STATE OF MAINE
 DEPARTMENT OF TRANSPORTATION
 16 STATE HOUSE STATION
 AUGUSTA, MAINE 04333-0016

August 10, 2012
 Subject: **Durham**
 Federal Project No: ER-1907(610)X
 State WIN: 019076.10
Amendment No. 5

DURHAM
ROUTE 136
GENERAL NOTES

DURHAM
ROUTE 136
PLANS

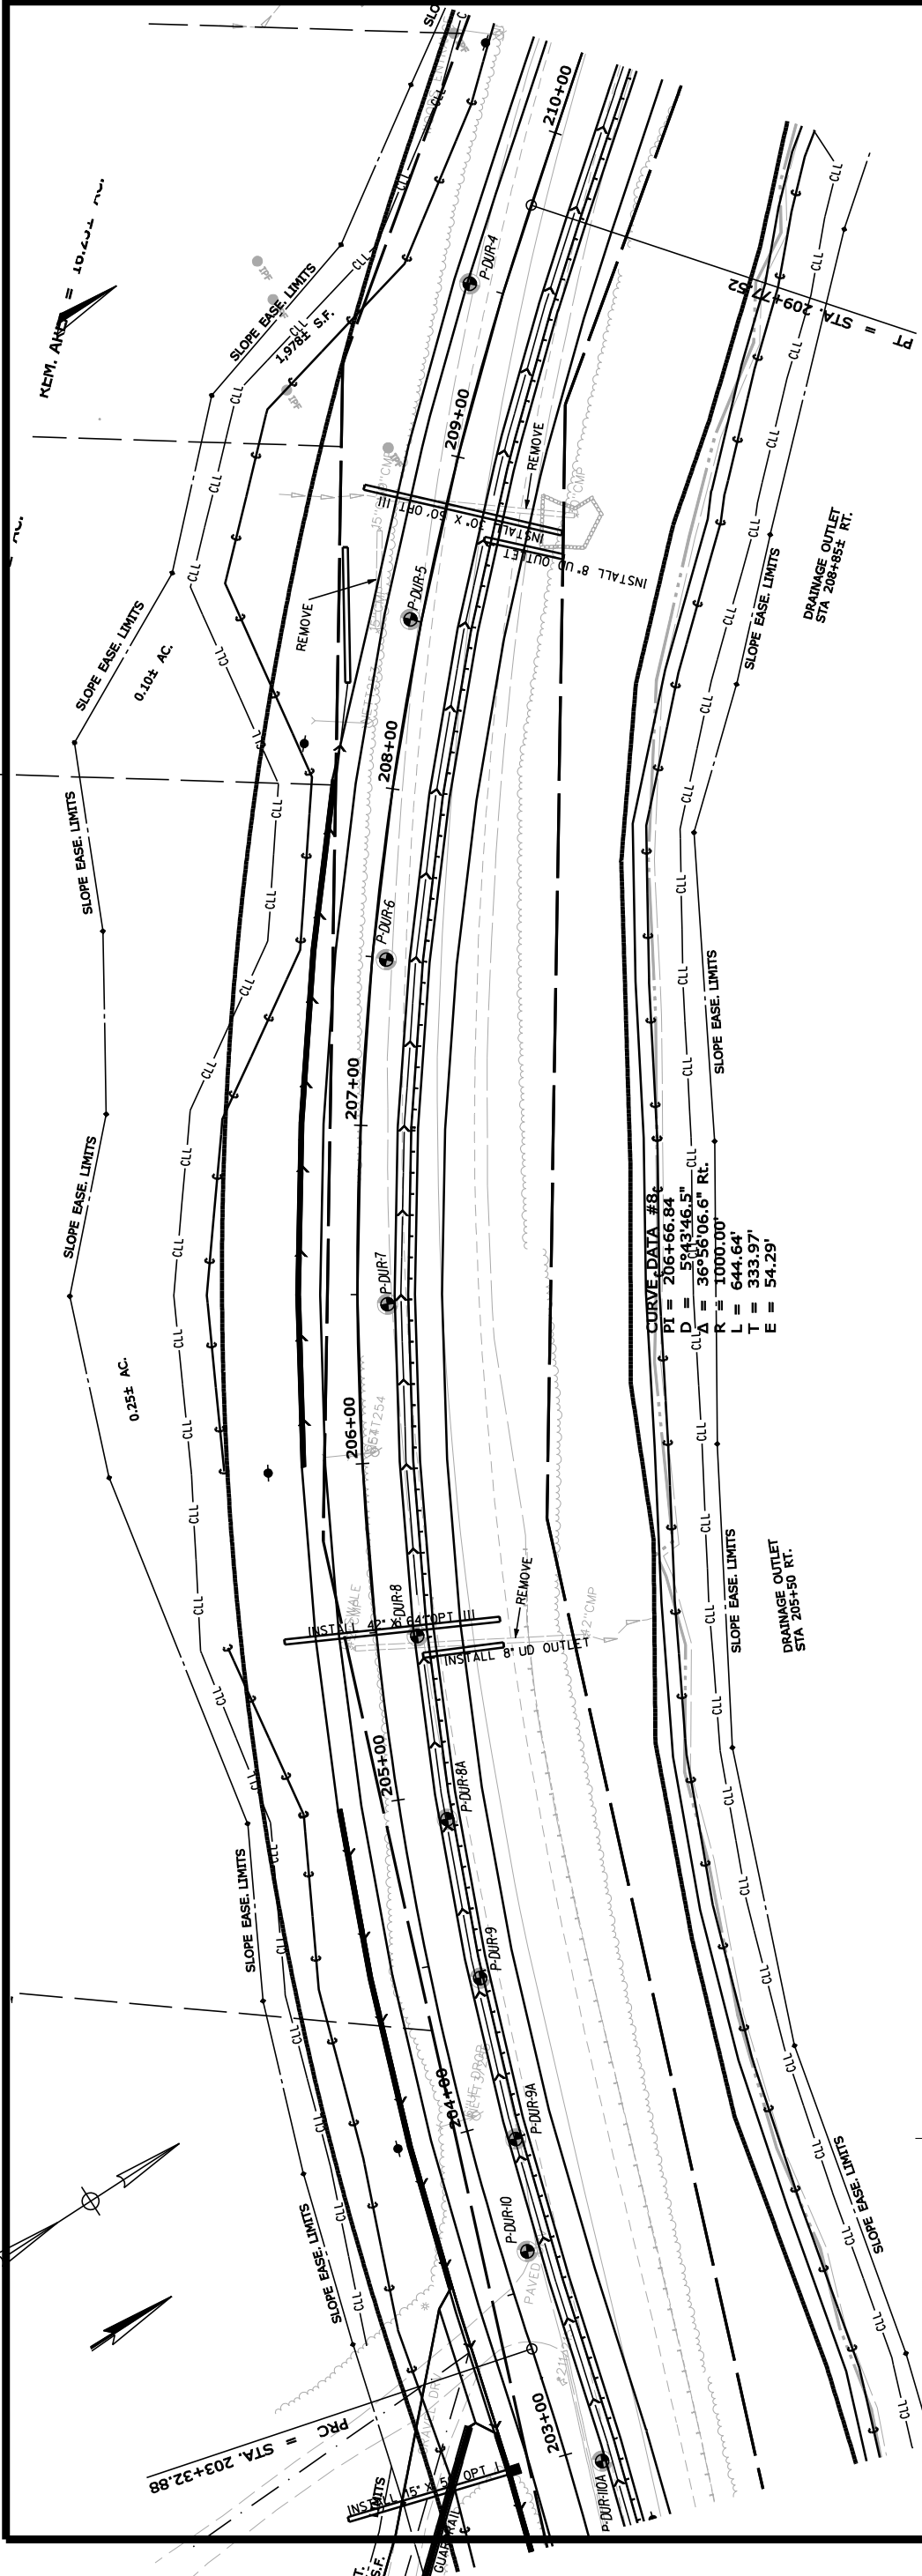
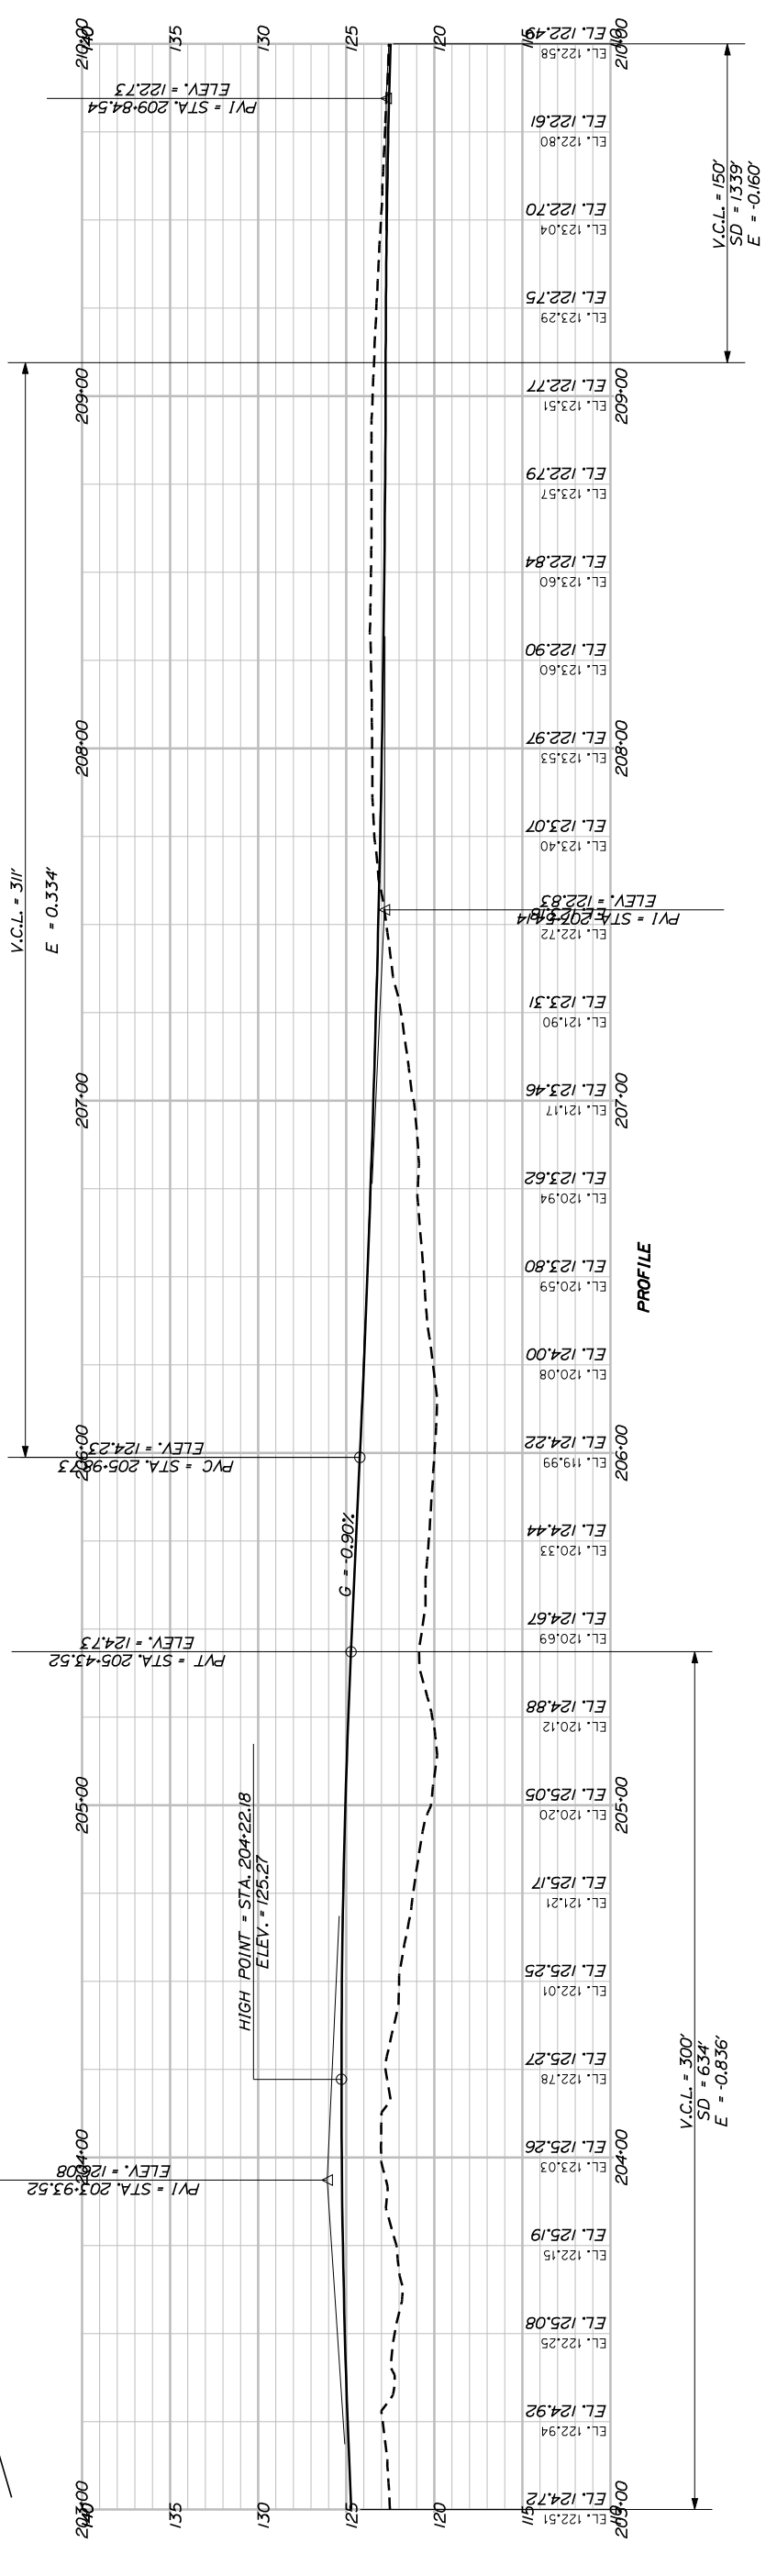
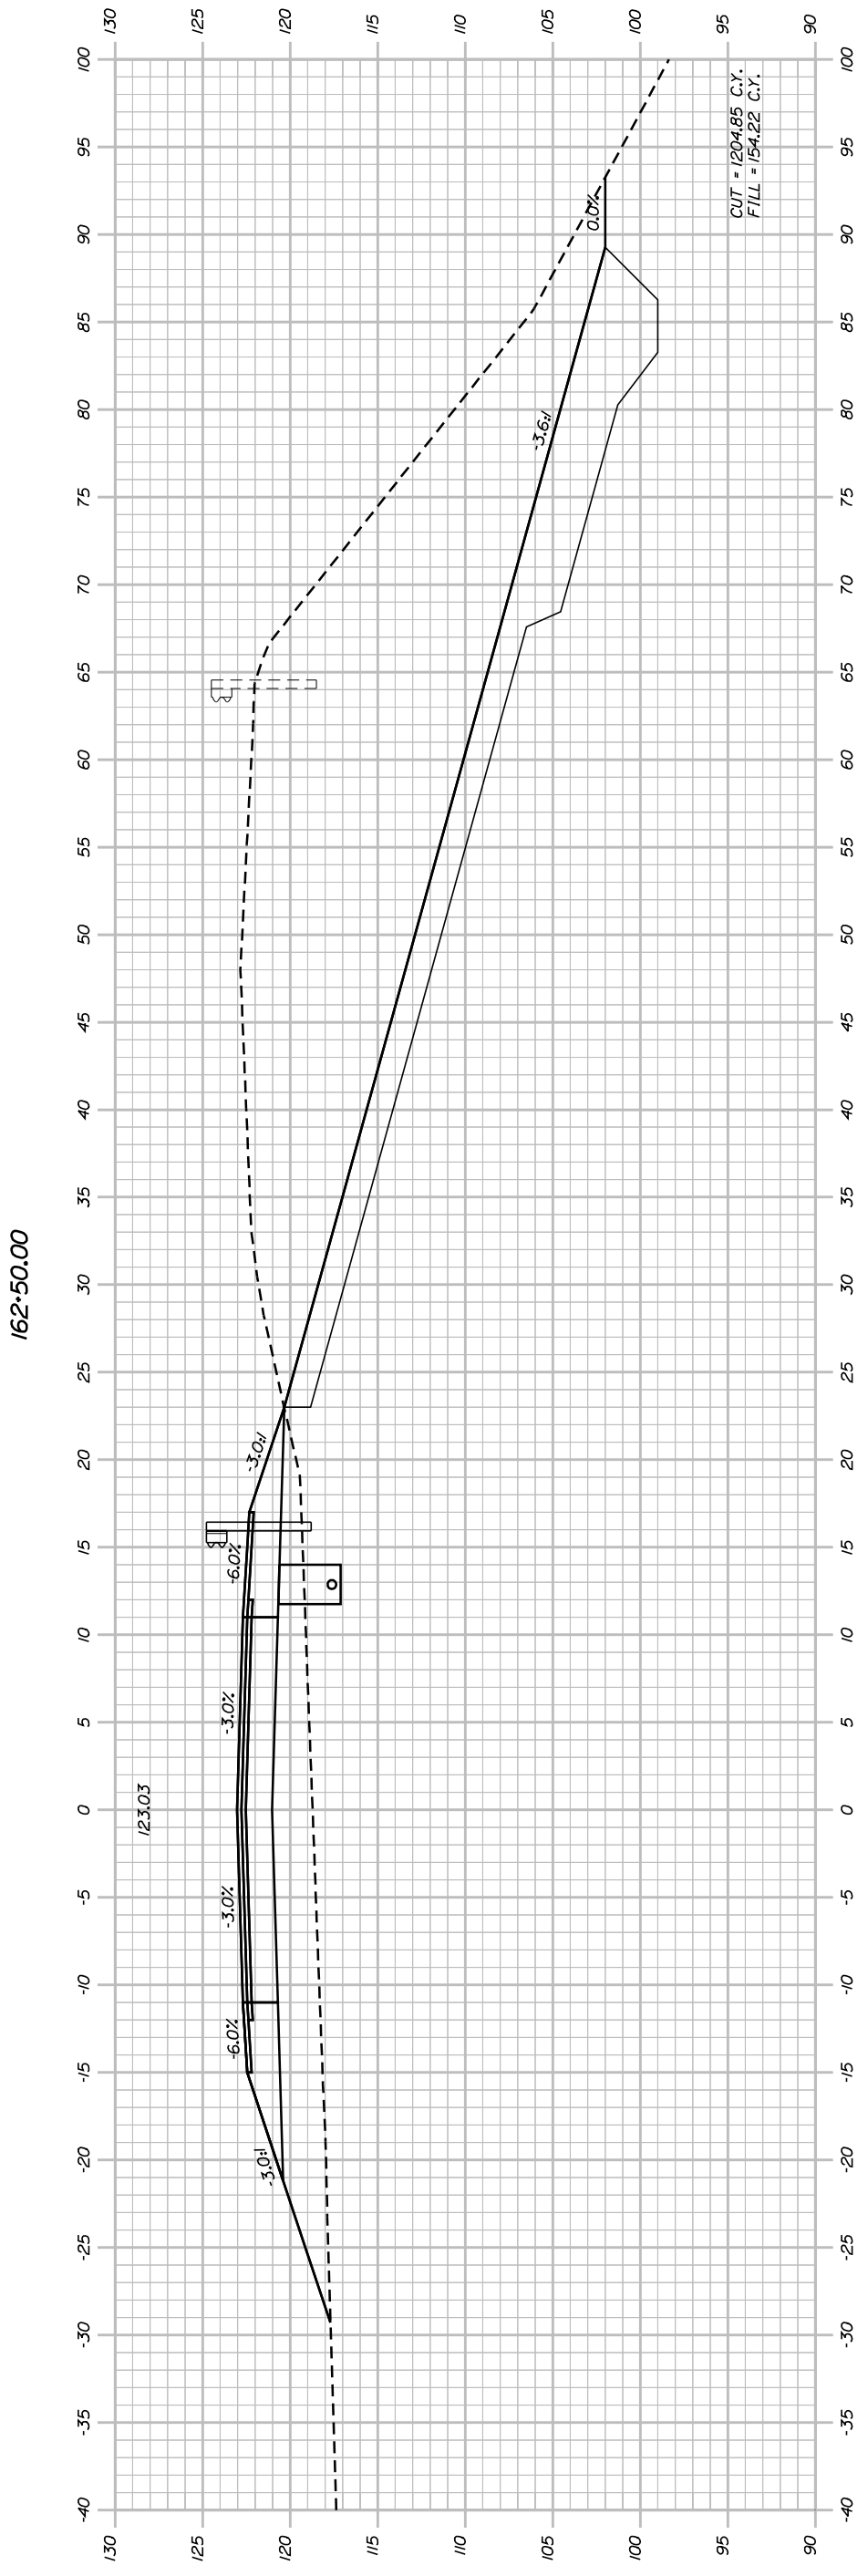
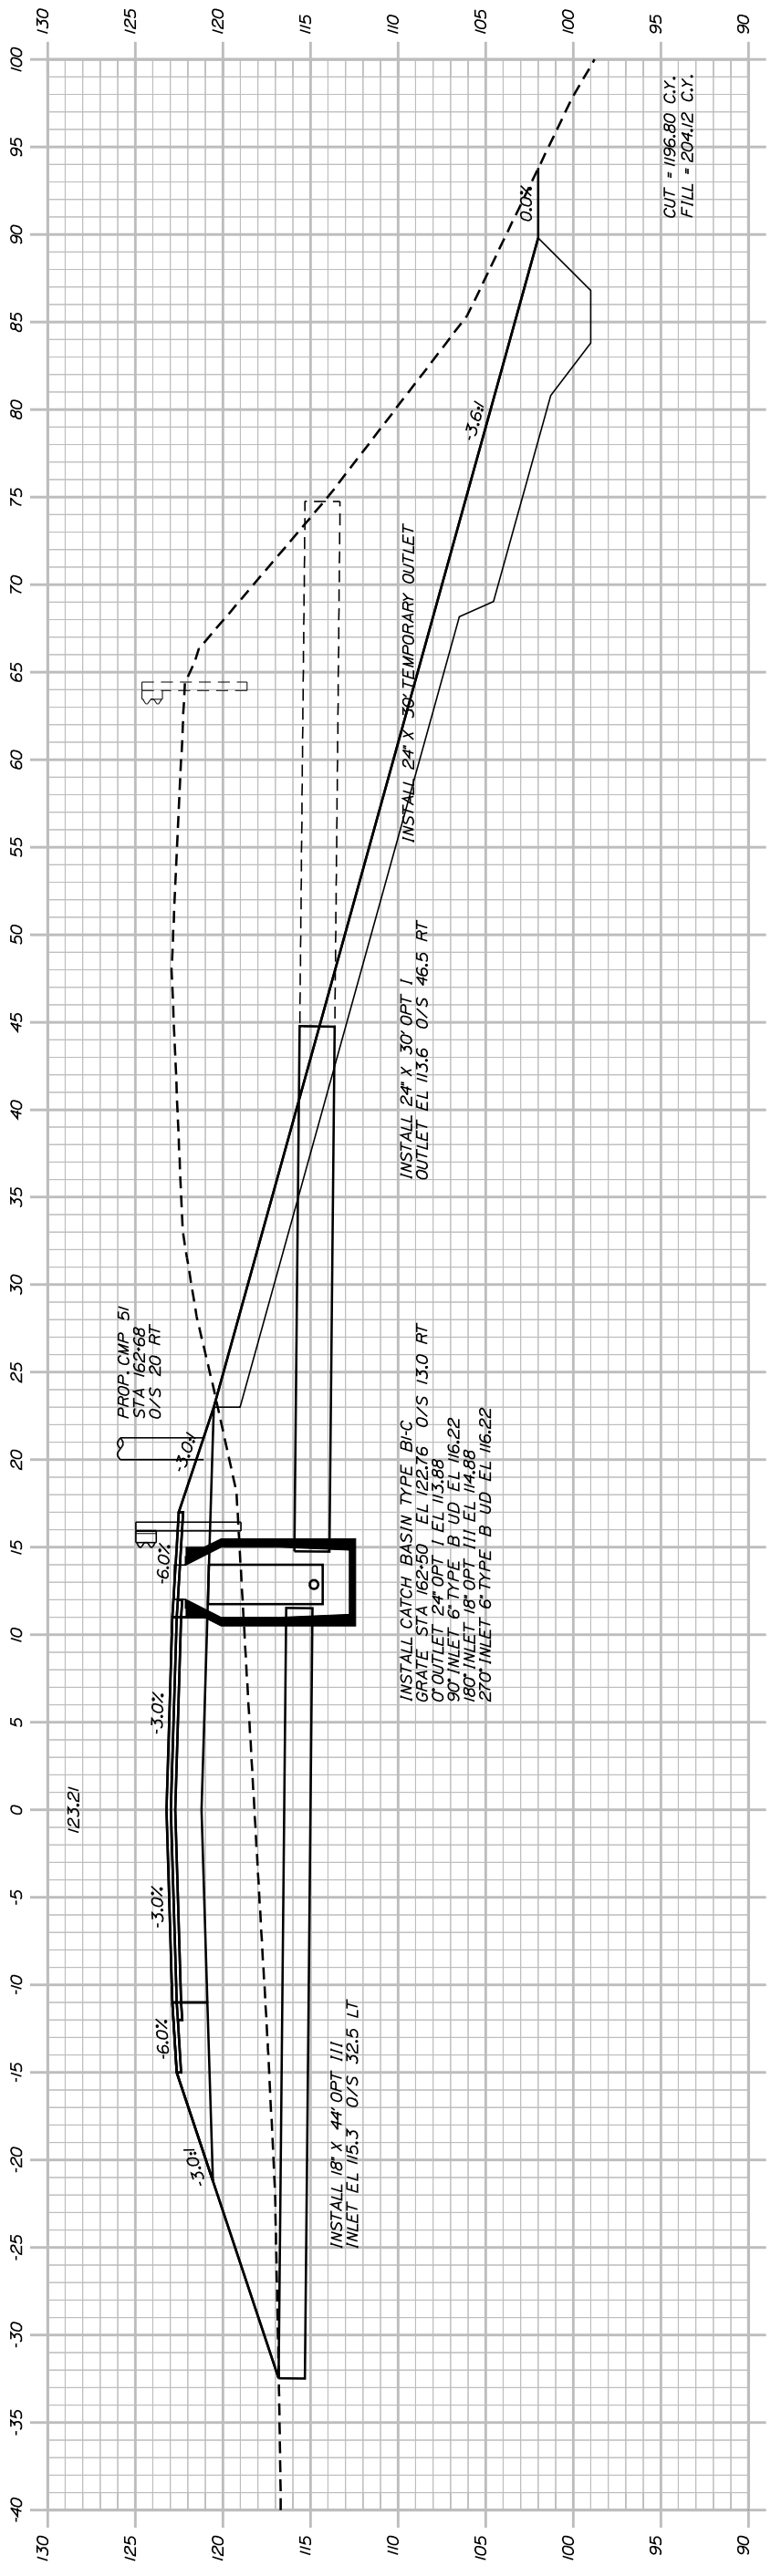
- 16 Plan display of additions. Timber Guardrail STA. 202+50 to 203+00 LT +/- along entrance. Catch Basin STA. 203+00. 15" Opt I STA. 203+00. 15" UD STA 201+00 to 203+00 LT.
- 17 New impacts to project LT STA. 205+50 to 208+50, addition of curb and 6" UD STA. 206+00 to 208+00 lt.
- 27,34,71,91 Addition of temporary outlets to sections. Sheet 91 includes new Catch Basin design for 15" UD
- 95 Detail for new catch basin STA. 203+00 LT.
- 101 Addition of temporary outlet to section.
- 102 – 106 Addition of Type B UD and curb with adjusted impacts. 2 utility pole elevation adjustments made. Cut and fill quantities NOT UPDATED.
